DEVELOPMENT REVIEW COMMITTEE (DRC) COMMENT REPORT

PROJECT NAME: 300 W. Broward

CASE NUMBER: UDP-S21052

REQUEST: Site Plan Level II Review: 956 Multifamily Residential Units, 23,752 Square Feet of Commercial Use with associated Parking Reduction Request in the Downtown Regional Activity Center

Quality of Architecture

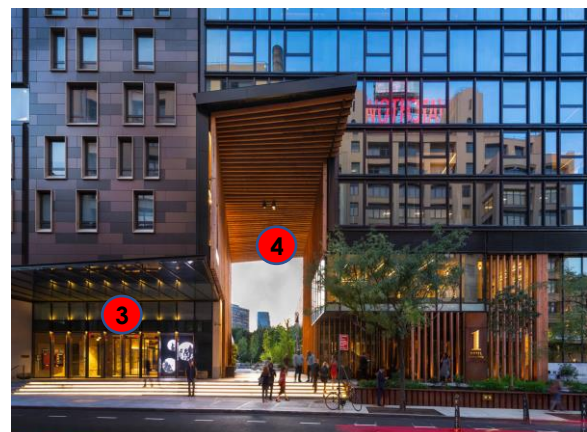
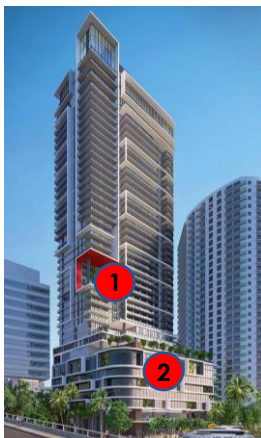
- j. Proposed tower does not meet DMP intent for skyline drama;
 - k. The tower top design should be revised to provide for greater expression, varying in design, contain sculptural features, and illuminate;

- l. Project does not contain high quality building materials as there are three materials labeled; stucco, windows, and architectural metal screening; and

- m. Proposed parking podium screening is not adequate as there is not enough design detail to understand the application of the screening material which should include product information and images, percentage of openness, and design approach.

6 Angular design

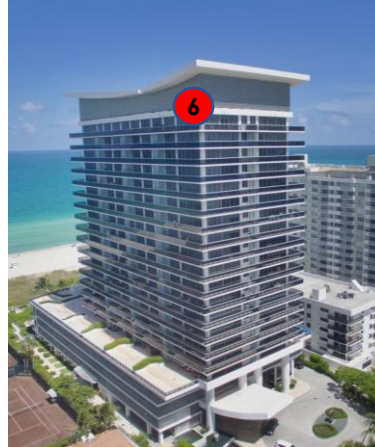
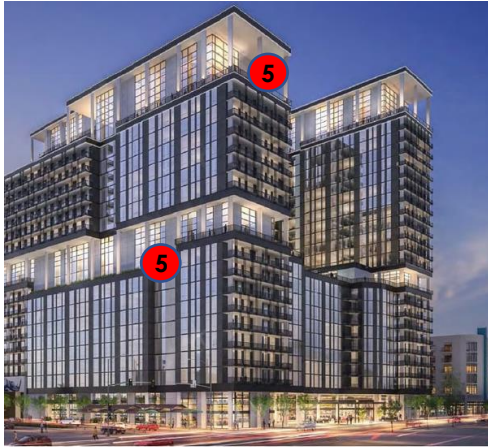
12. The proposed building design needs to be revised to address the following. Refer to images below as design examples;
- a. The requested site deviations for increased podium height, increased building height, larger floorplates, collectively create issues with the design intent established in the DMP. Appropriate placement and compatible building design are important for this site given the context and visibility. In addition, the balconies encroach in the tower separation distance and building setbacks, which only furthers the enormous appearance of the building. Applicant should re-examine the overall building design;

- b. The building is significantly larger in mass and scale than the immediate surroundings. Mitigate building mass by incorporating a stepback along Broward Boulevard and provide transition in the design by scaling the building back from southern property line, paying particular attention to the distance and proximity to the historic district. Include architectural elements that increase the visual interest of the building such as vertical banding, tower verticality, etc.

- c. The lower levels of the building at pedestrian scale, should be redesigned to incorporate a significant floor to ceiling height in relation to the overall scale of the building and should continue along the full streetwall length of the building. Building corners should contain significant architectural features that are proportionate to the overall project scale with significant projections, change in material, and other design techniques, cut-through passageways, etc.;

- d. Tower top design does not achieve the design intent outlined in the DMP for dramatic skyline composition nor does it contain a sculptural design, unique feature, or angular element. Revise the top of the tower to meet this intent;
